RE: ***Anclote Harbor Apartments
East of US 19 and North of Live Oak Street
Response to Gap Study Review Comments***

Please see below for responses to comments dated January 4, 2021 for the Anclote Harbor Apartments Gap Study.

FIGURE 3: AM PEAK HOUR PROJECT TRAFFIC

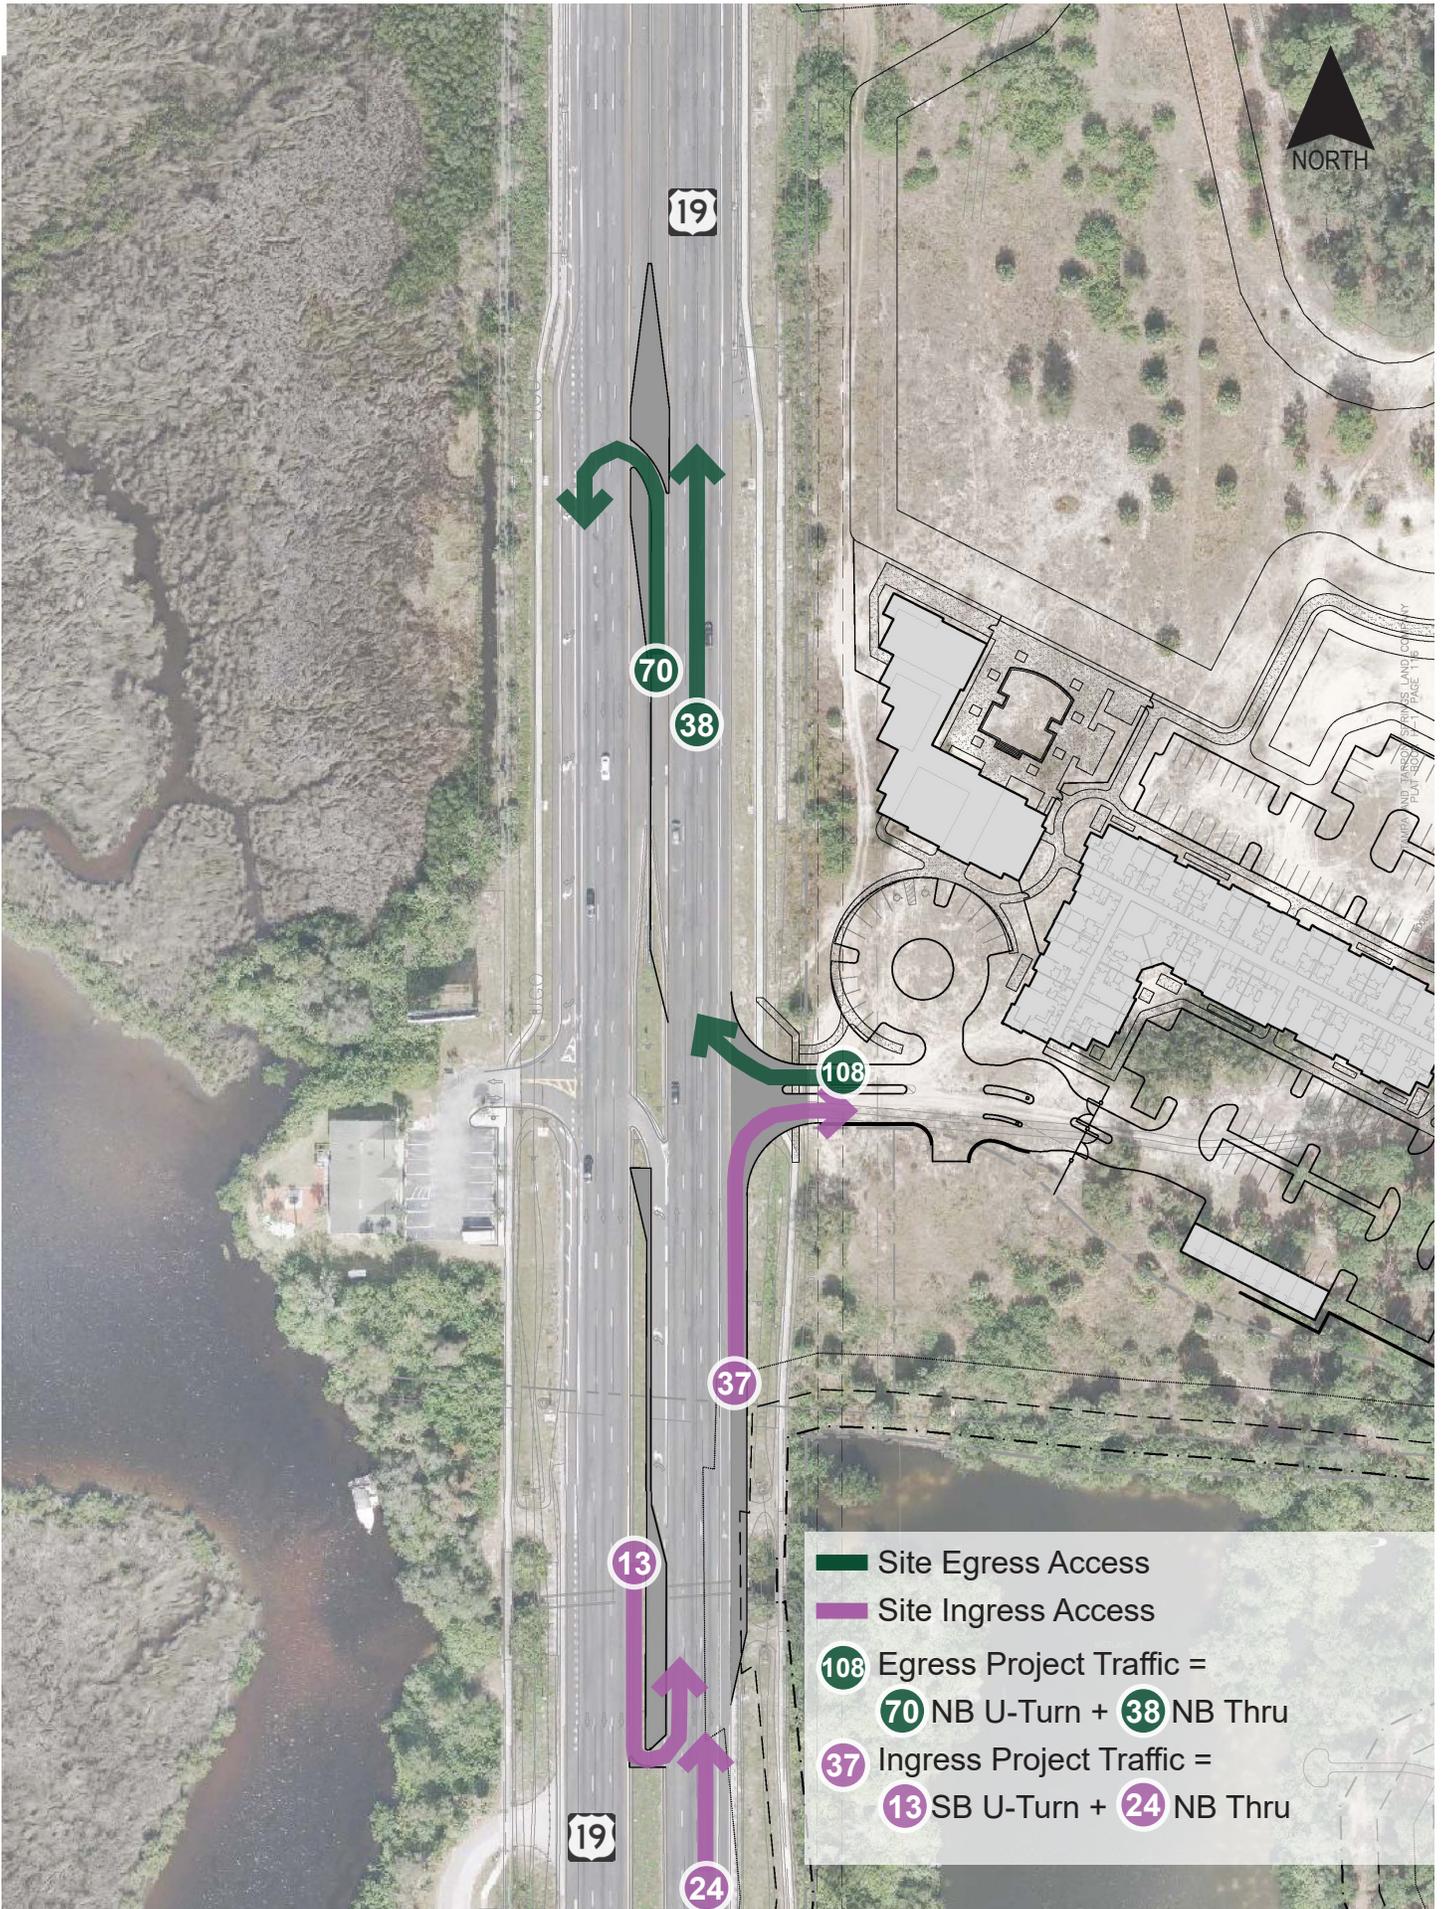
Comment 2: In Figure 2, Figure 3 and Figure 4 remove “southbound” from the legend. The ingress traffic technically travels westbound then northbound before making a U-turn southbound.

Response 2: Figure 3 and Figure 4 have been updated accordingly to remove the “southbound” from the legend and are attached.
